## SM ROCHA, LLC

Add PCD Project #  
AL 21-015

RE: Venetucci Farm / Traffic Generation and Impact Analysis  
El Paso County, Colorado

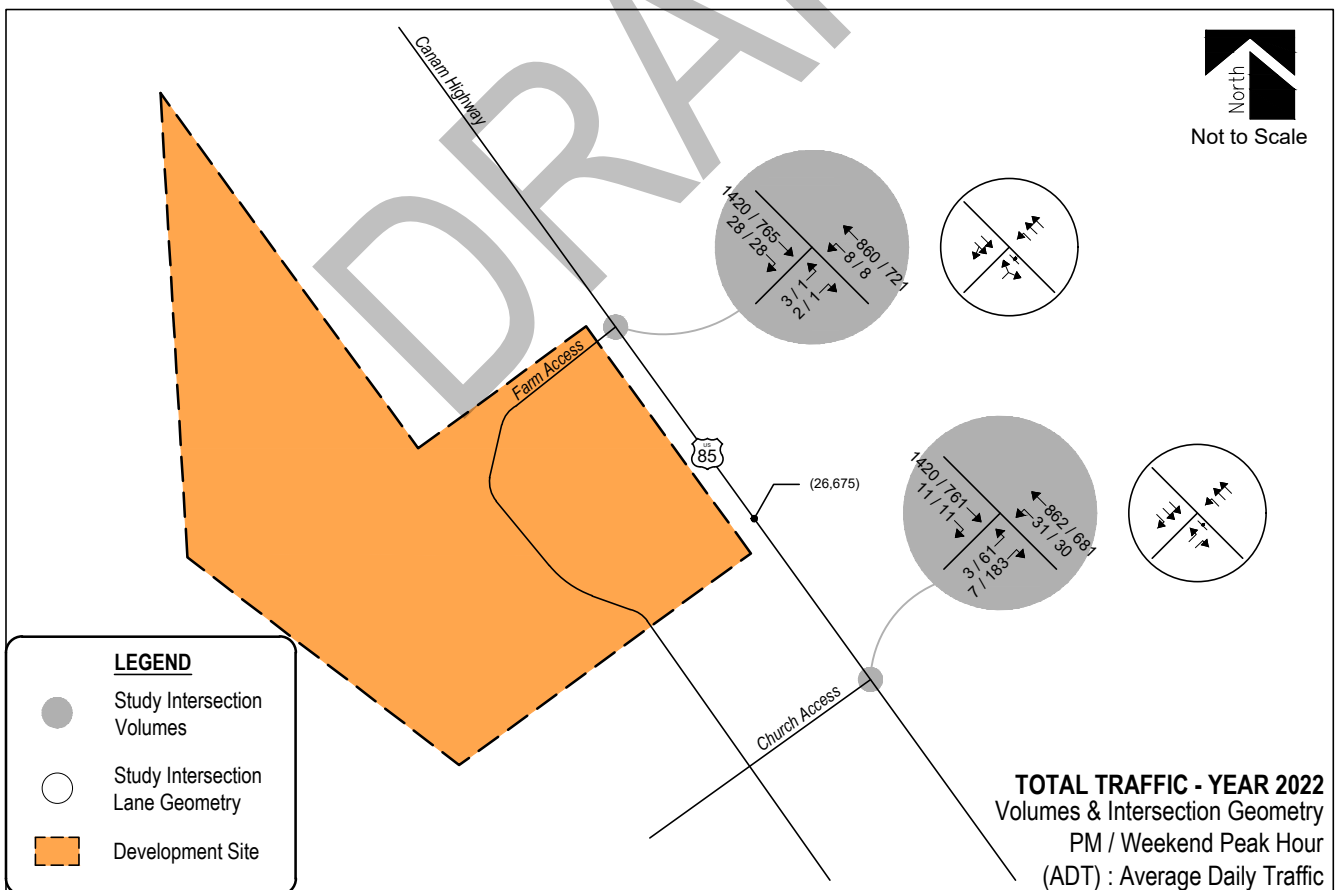
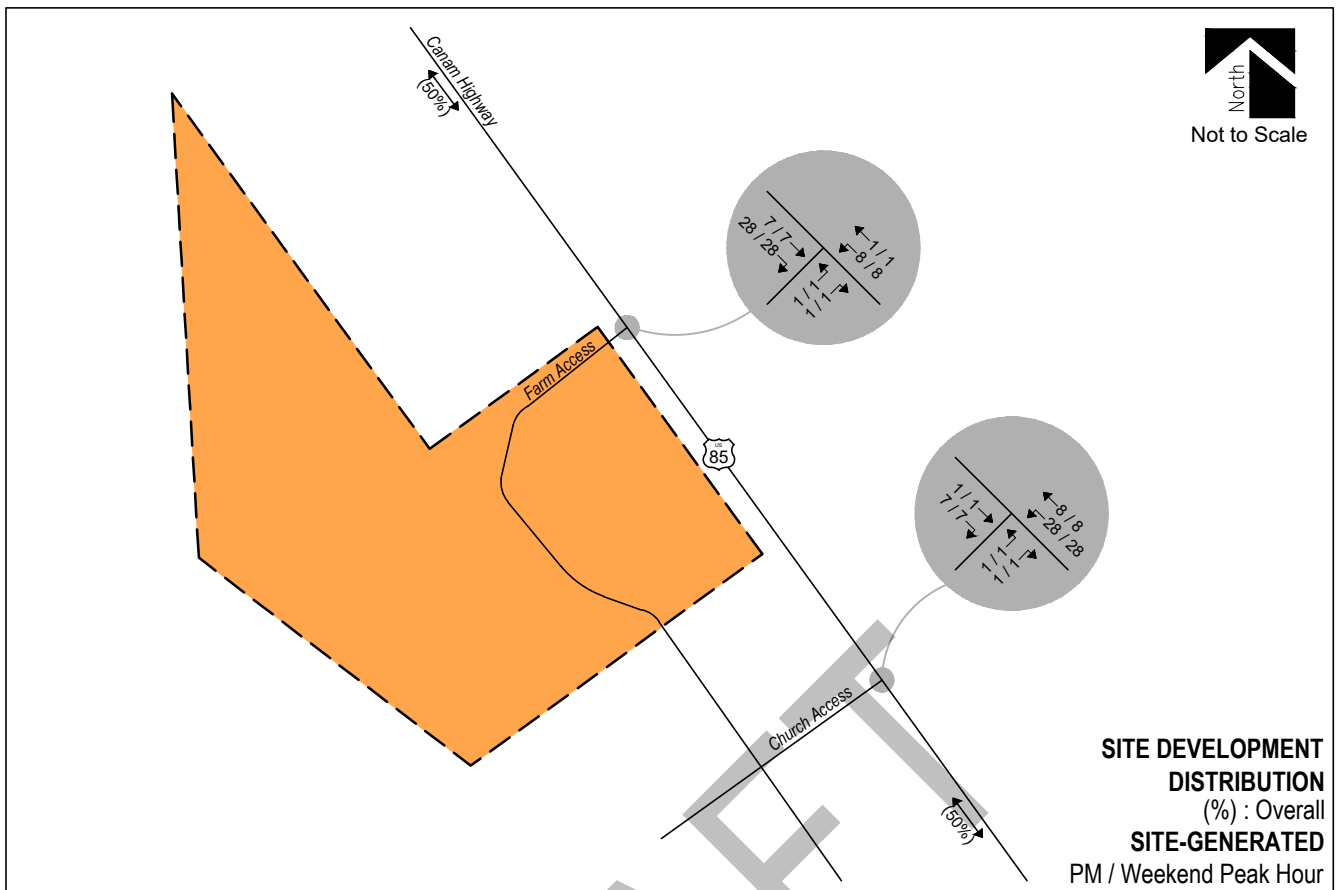
Discuss traffic impacts in the event the wedding venue occurs at the same time as church services on Sundays. It seems a worse-case scenario is having both church service and guest for the wedding venue arriving at the same time.
